GOVERNMENT OF PUERTO RICO  
PUBLIC SERVICE REGULATORY BOARD  
PUERTO RICO ENERGY BUREAU

IN RE: PLAN PRIORITARIO PARA LA  
ESTABILIZACIÓN DE LA RED ELÉCTRICA

CASE NO.: NEPR-MI-2024-0005

RESOLUTION AND ORDER

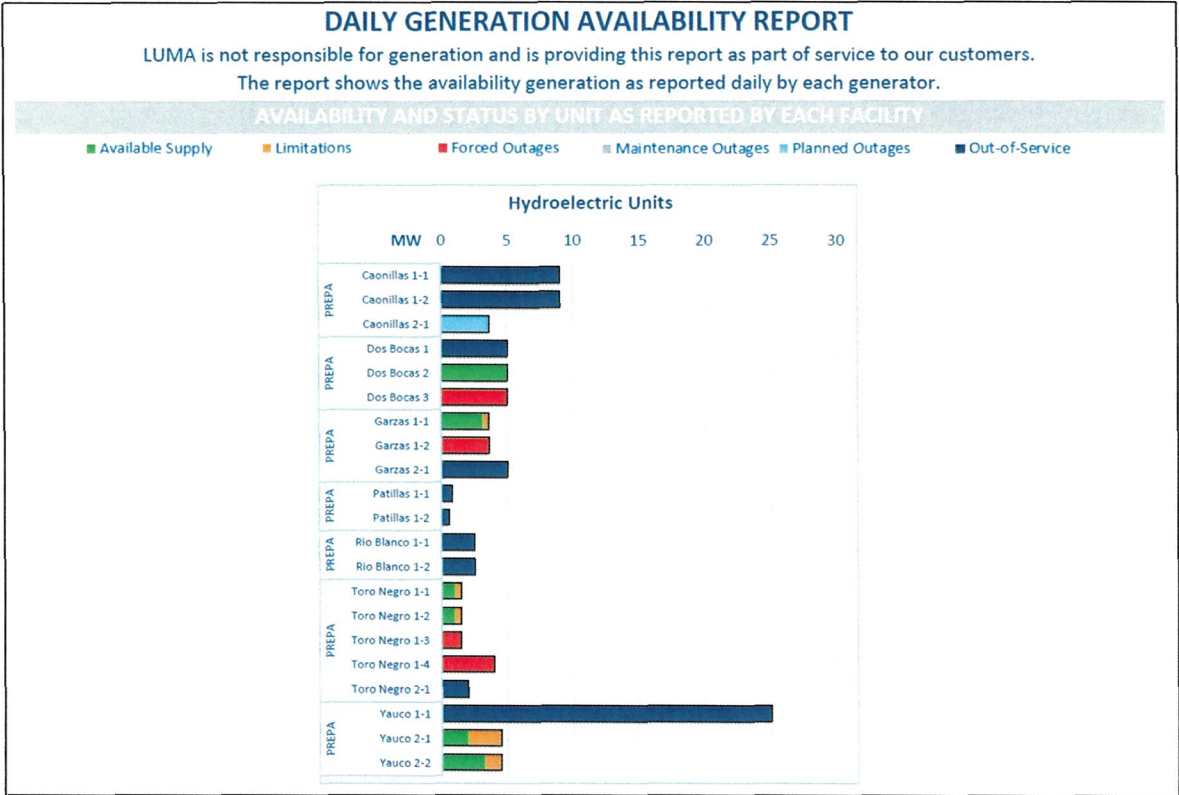
1. On July 17, 2024 the Daily System Status received by the Energy Bureau depicted the status of the hydroelectric units as follows:

The Toro Negro 1-3 unit is depicted as unavailable due to a forced outage, however PREPA states in the plan it submitted to the Energy Bureau on July 19, 2024 that this unit is available.<sup>5</sup> Explain this discrepancy.
